Fenton Street Bikeway Study Alternatives Selection

Completed: 01/13/2021

Applicant: Montgomery County Department of Transportation

Figure 4: Fenton Street/Silver Spring Avenue Intersection

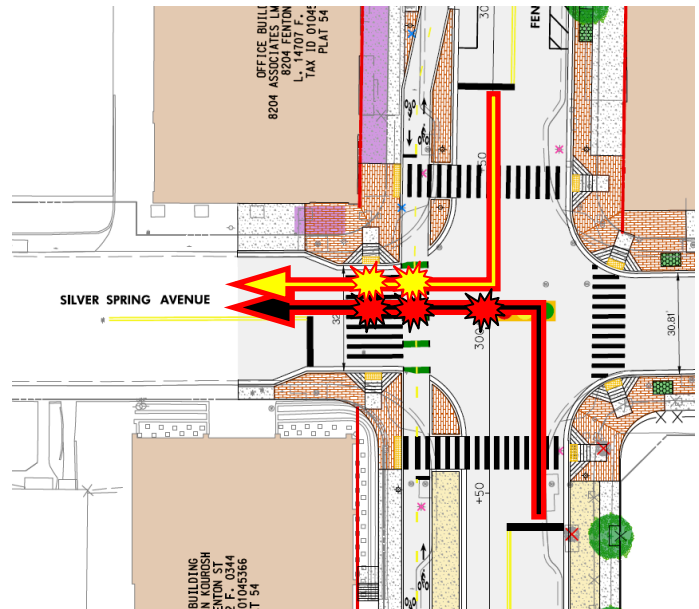
Left turns are typically more dangerous than right turns for a few reasons. First, motorists tend to accelerate when turning left, and greater speeds are associated with greater crash severity. Second, left turns result in additional conflicts. For instance, in *Figure 4*, making a right turn from southbound Fenton Street onto westbound Silver Spring Avenue, a driver must cross a two-way separated bike lane and a crosswalk (yellow arrow). These represent two conflict points. A driver making a left turn onto westbound Silver Spring Avenue must address the same conflicts, but also cross a lane of oncoming motor vehicle traffic (red arrow).

Figure 10: Fenton Street/Wayne Avenue Intersection

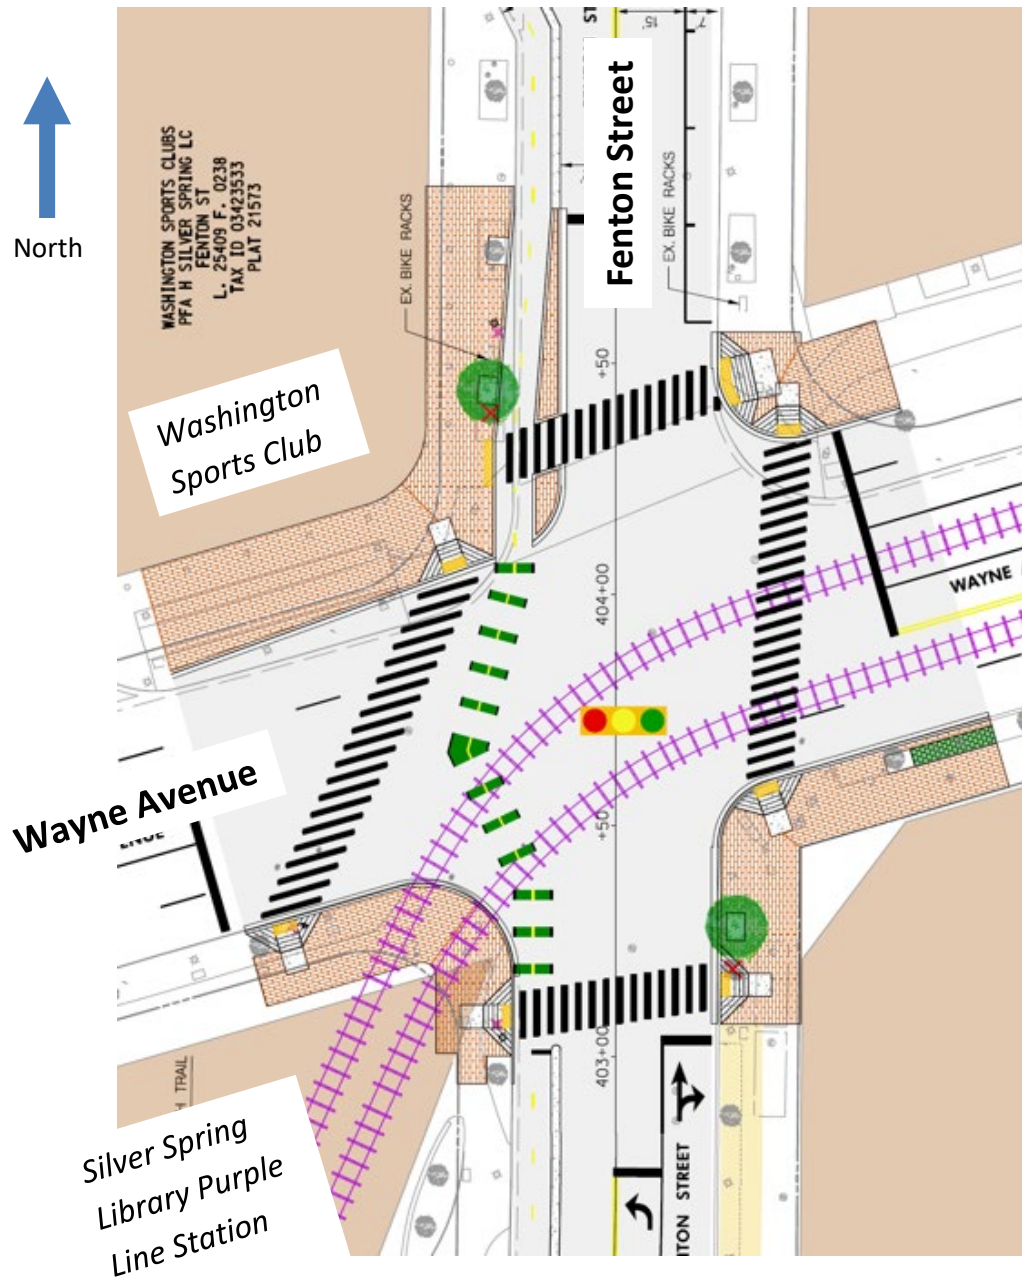
The Purple Line will help people from across the region access the Fenton Street corridor. The station at the Silver Spring Library is within a very short walk of Fenton Village and the Ellsworth District. *Figure 10* illustrates how the intersection is currently designed in all alternatives.

The orientation of the Purple Line tracks through the intersection make it very difficult for pedestrians and bicyclists to safely and directly cross the west leg of the intersection. The bike lane markings have an awkward bend in them to encourage bicyclists to cross the Purple Line tracks at as close to a 90-degree angle as possible. This reduces the likelihood of a bicyclist crashing by getting a wheel caught in the trackbed. These markings encourage the safest riding behavior, but they are not likely to be followed. Most bicyclists will continue straight across the intersection.

Similarly, the western curb ramps and crosswalk markings are shown in a configuration that pedestrians are not likely to comply with. Pedestrians are more likely to walk in the bikeway at this location or cross outside the crosswalk as the marked crossing is not along a likely path of travel for most people. Finally, pedestrian waiting space is very limited at the southwest corner of this intersection and pedestrians are likely to overflow into the bike lanes or onto the Purple Line tracks.

Staff will engage MCDOT in a design process to improve this important intersection and increase compliance with crossing markings on the western leg.

- 1. Advance Alternative E as the preferred alternative.**
- 2. Coordinate with Montgomery Planning staff to undertake a design process to better separate pedestrians, bicyclists, motor vehicles and light rail vehicles at the Fenton Street/Wayne Avenue intersection.**
